**SUBJECT: WATERFORD STEAM ELECTRIC STATION, UNIT 3 – NRC INTEGRATED
INSPECTION REPORT 05000382/2015-003**

Docket: 05000382
License: NPF-38
Report: 05000382/2015003
Licensee: Entergy Operations, Inc.
Facility: Waterford Steam Electric Station, Unit 3
Location: 17265 River Road
Killona, LA 70057
Dates: July 1 through September 30, 2015
Inspectors: F. Ramírez, Senior Resident Inspector
C. Speer, Resident Inspector
T. Sullivan, Project Engineer
K. Ellis, Senior Resident Inspector
B. Larson, Senior Operations Engineer
C. Cowdrey, Operations Engineer
C. Steely, Operations Engineer
P. Elkmann, Senior Emergency Preparedness Inspector
Approved By: Geoffrey B. Miller
Chief, Projects Branch D
Division of Reactor Projects

IR 05000382/2015003; 07/01/2015 – 09/30/2015; Waterford Steam Electric Station, Unit 3; Follow-up of Events and Notices of Enforcement Discretion.

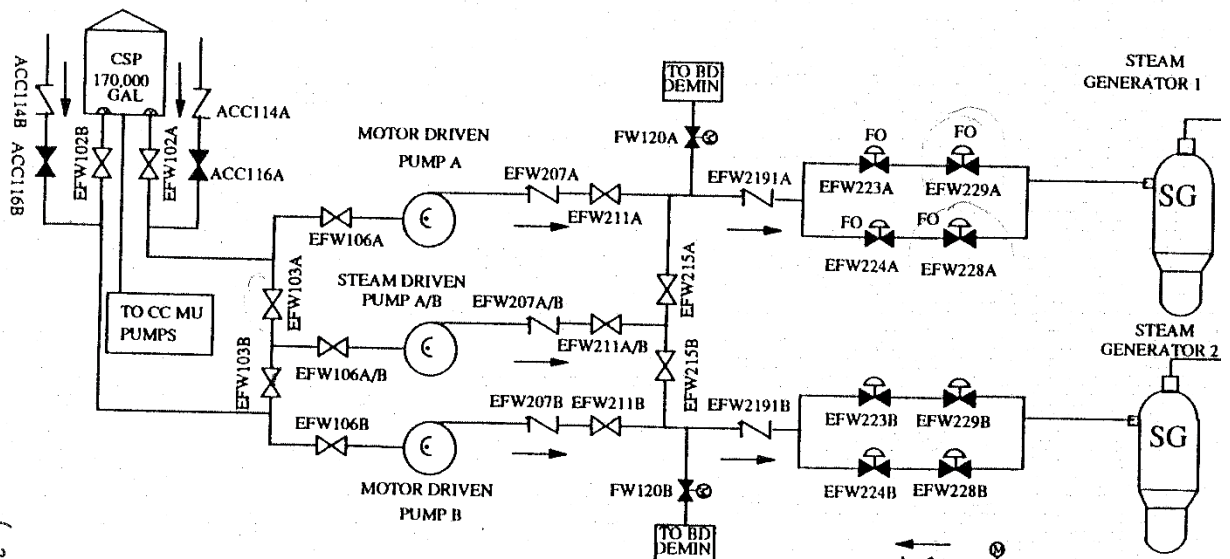
The expected response from the system should have been a slow convergence of emergency feedwater flow to the 400 gpm set point. Instead, at 5:09 pm the operators observed wide frequent oscillations in emergency feedwater flow. These fluctuations, which ranged between 400-800 gpm every 7-8 seconds, were not consistent with the expected system response. To prevent further oscillations, the control room operators took manual control of the backup flow control valves. This action also prevented the depletion of the nitrogen accumulators prior to the credited mission time. The oscillations stopped at 5:15 pm, and operators manually controlled flow to the steam generators during the rest of the event, until the emergency feedwater actuation signal was secured.

that no periodic testing confirmed the stability of the backup flow control valves in the automatic flow control mode. Since the system's ability to automatically control flow using these flow control valves was never tested, the improper design had not been identified. The inspectors therefore considered that the cause of the licensee's failure to test the stability of the backup flow control valves in the automatic flow control mode was an oversight that occurred around the time of initial plant startup in 1985.

On June 3, 2015, in response to a loss of feedwater event and a plant trip, operators noted that the backup emergency feedwater flow control valves (EFW-223A/B) were oscillating. The precise amount of oscillation was not reported but it was considered significant. Operators took manual control of the backup emergency feedwater flow control valves and established steam generator levels within the desired parameters.

To restore the emergency feedwater system to operable status, the licensee stationed a dedicated operator in the control room to operate the backup flow control valves in manual following a reactor trip. This action not only prevented valve oscillations but also limited the depletion of the nitrogen accumulators servicing the emergency feedwater valves and other valves in safety-related systems.

Contrary to the above, prior to June 3, 2015, design control measures did not provide for verifying or checking the adequacy of design, in that the design control measures did not ensure that, as described in the licensee's design basis, the emergency feedwater system back-up flow control valves could automatically control steam generator level after a loss of main feedwater event. As a result, on June 3, 2015, following a manual plant trip that occurred due to a loss of main feedwater system, the emergency feedwater back-up flow control valves oscillated so severely that control room personnel removed the system from automatic operations and manually controlled flow to steam generators. The licensee entered this condition into their corrective action program as condition report CR-WF3-2015-3565. To restore compliance, long term corrective actions are to develop a modification to the system for better flow control, and implement testing that would verify the automatic function of these valves.
